MOS24/1136/33
15 March 2024

RE: NON-COMPLIANCE PENALTY IN TERMS OF THE ENVIRONMENTAL MANAGEMENT PROGRAMME FOR FAILURE TO INSTALL NO-GO DEMARCATION – ERF 4716, GROOT BRAK RIVIER

14 March 2024

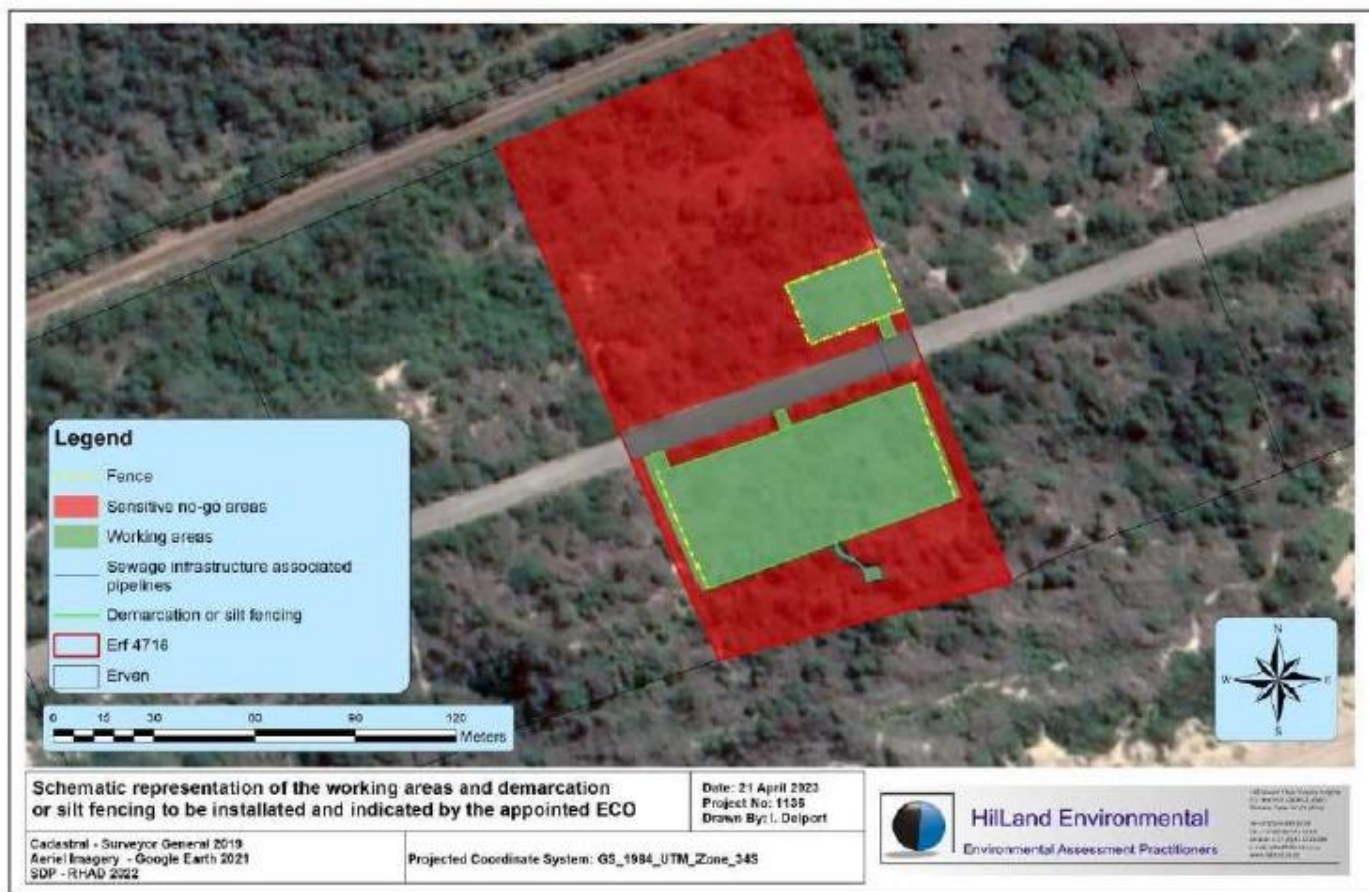
The contractor was requested to install the No-Go demarcation for the garage site on May 2023, written request on the WhatsApp group on 1st March 2024 and second verbal request on 12th March 2024. During our follow-up inspection on 14th March 2024, the No-Go demarcation had still not been installed for the garage site and as result thereof, workers are walking through the No-Go zone where the Milkwood trees were transplanted to.

Damage to and protection of the transplanted milkwood trees – the trees transplanted have been damaged through construction activities and failure to demarcate and protected the trees. Thank you for now demarcating the trees, however access through the No-Go area is still disturbing these trees, they need to be watered daily. In order to try revive these trees please include compost around the trees and an application of Bounce back or similar product.

Shade netting to be installed around the working area as required.

The contractor is hereby instructed to install the No-Go demarcation for the garage site by no later than 16 March 2024 and submit photographic proof thereof to the ECO.
